# NOTICE OF APPLICATION & PUBLIC MEETING NOTICE

## Medway Valley ESA (South) Conservation Master Plan Phase II, and Official Plan Amendment and Zoning By-law Amendment

# Medway Valley Heritage Forest Environmentally Significant Area (ESA)

**File: OZ-9367**

# Points of Interest

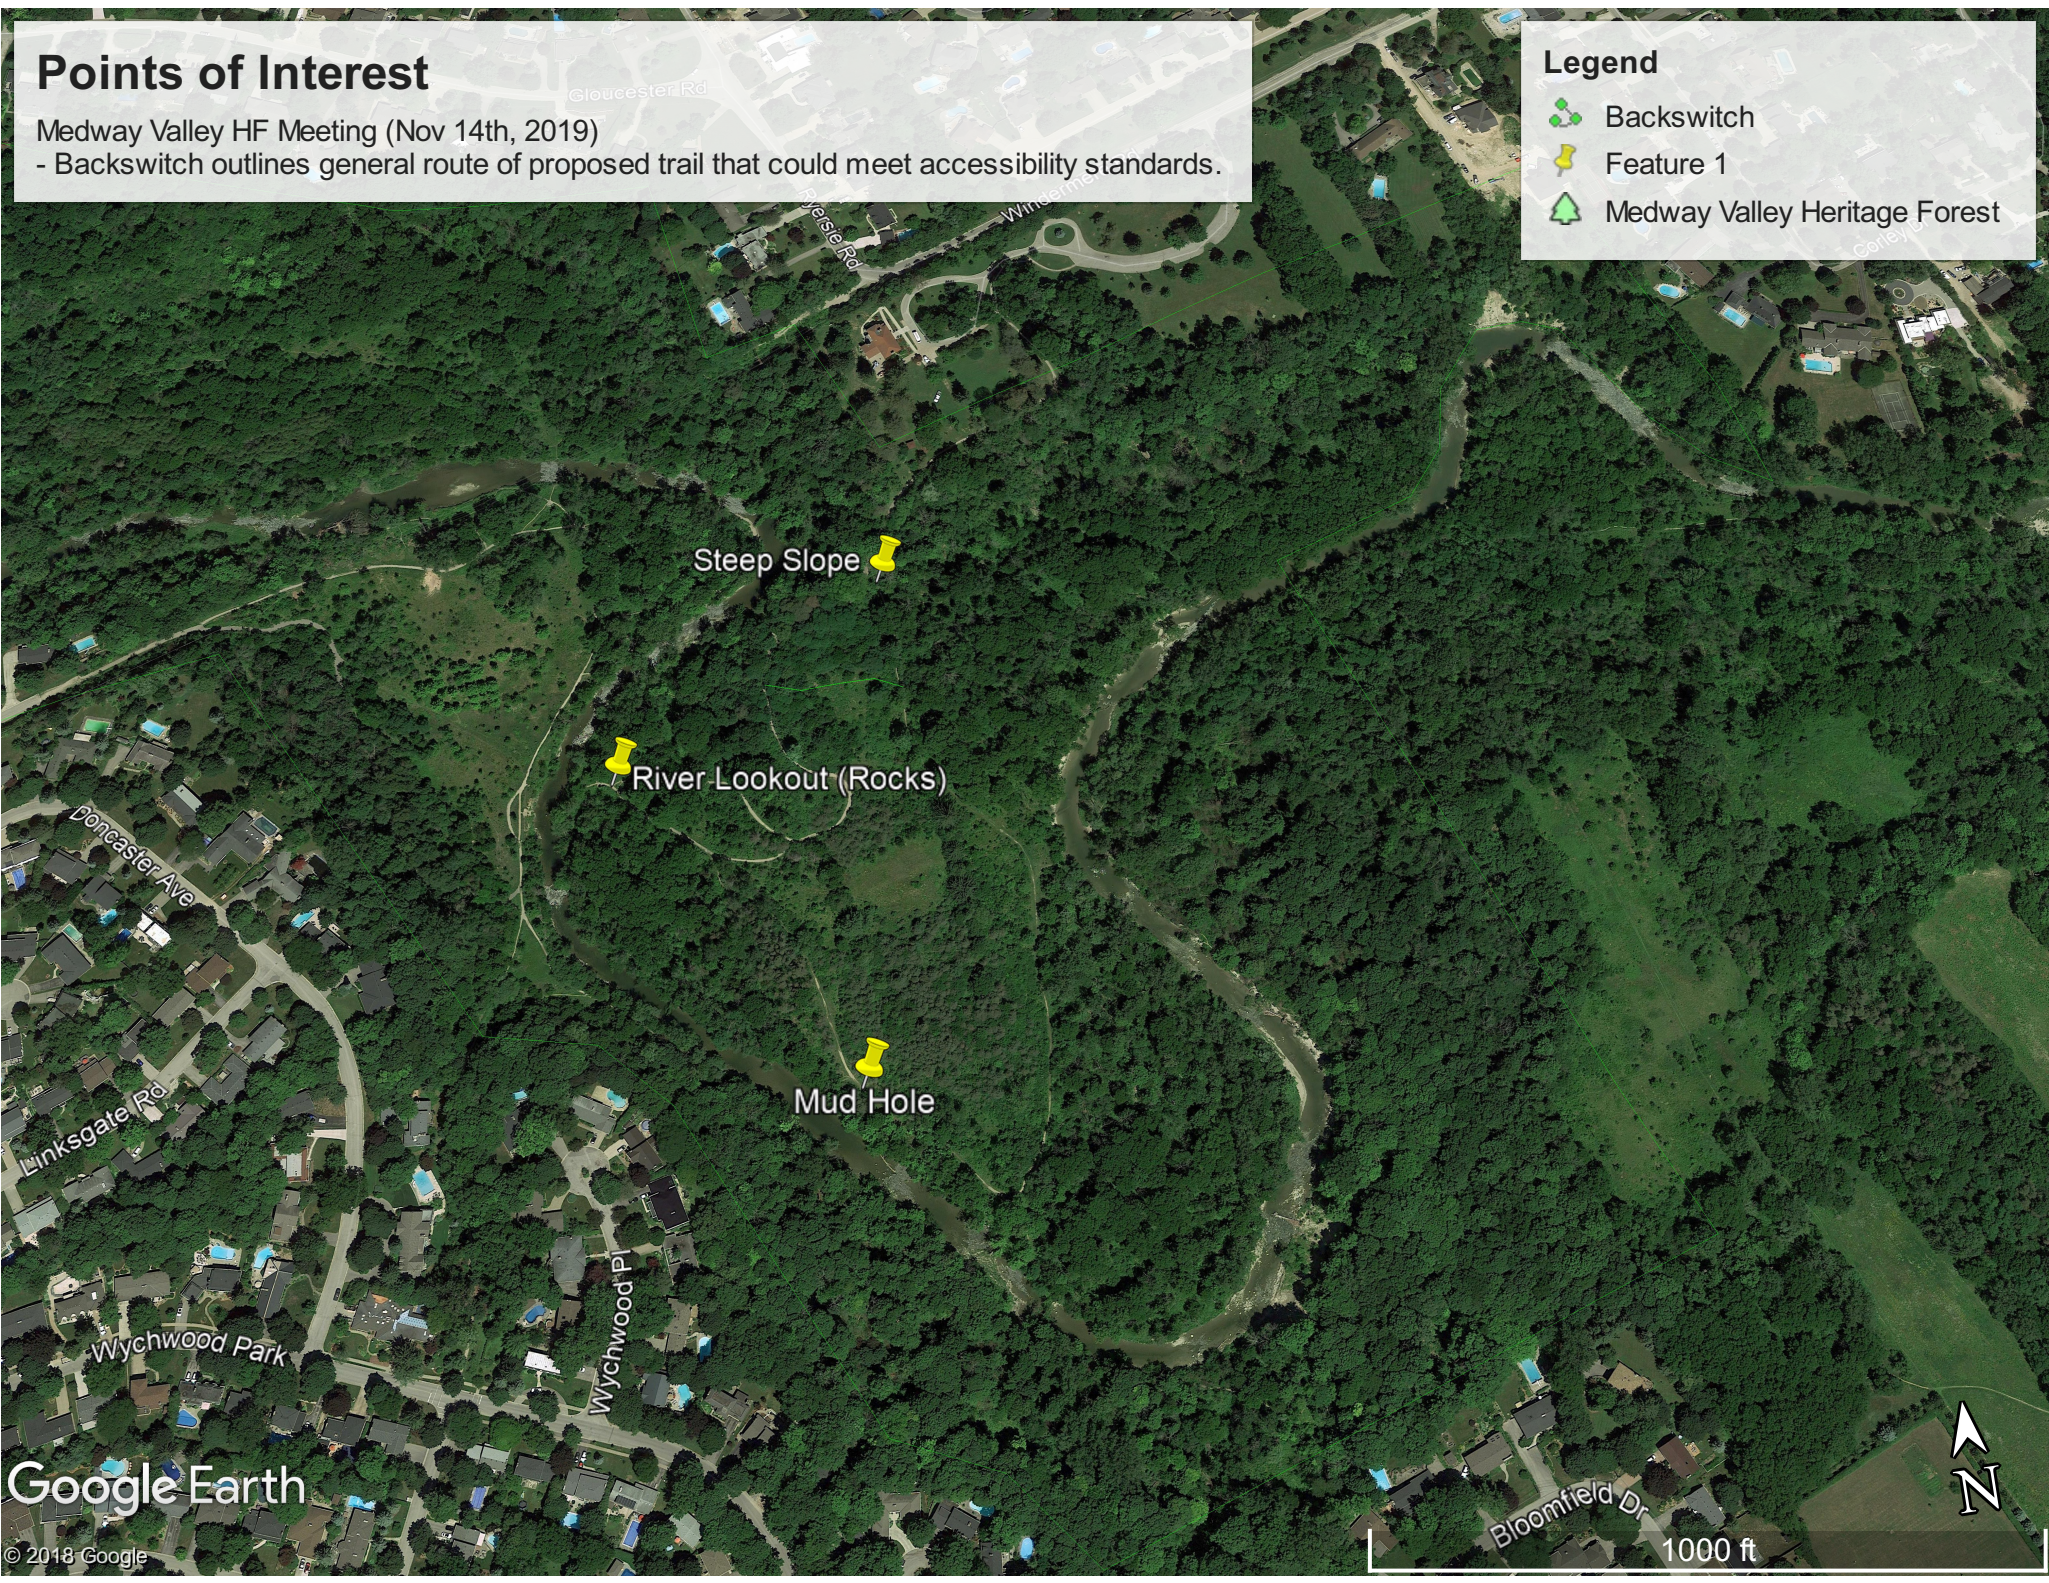
- We identified two trail sections that have accessibility issues, including: the 'mud hole' and the steep slope near the EPW entrance (see Map).
- We also identified that encroachment is occurring immediately along the river bank. Specifically, near the river lookout with the large rocks (see Map).

- CITY and EEPAC rep. identified that an additional two large rocks could be placed at this lookout to deter encroachment onto the river bank.
- CITY rep. identified the 'mud hole' as an accessibility issue. How to make this surface 'firm and stable' has not yet been determined. Regardless of the substrate used, some sort of drainage will be needed at this section.

- EEPAC rep. identified that the addition of a trail section between two flatter parts of the entrance-exit trails would allow us to bypass the steep slope. The trail section on the steep slope would be closed and restored.

- The yellow trail sign would need to be removed.
  - A spring inventory, restoration measures, and measures to reduce encroachment would need to be conducted in the proposed area. Several trees and / or Red Osier Dogwood could be planted on the slope to block the view of the trail section below, and limit encroachment.

- What is an acceptable 'firm and stable' plan for these areas? How will it be implemented? We should meet once more prior to Spring to discuss next steps.
- Discuss options for river crossings, including costs and benefits of crossings.
- Once accessibility is confirmed, we can bring the CMP back to the public.
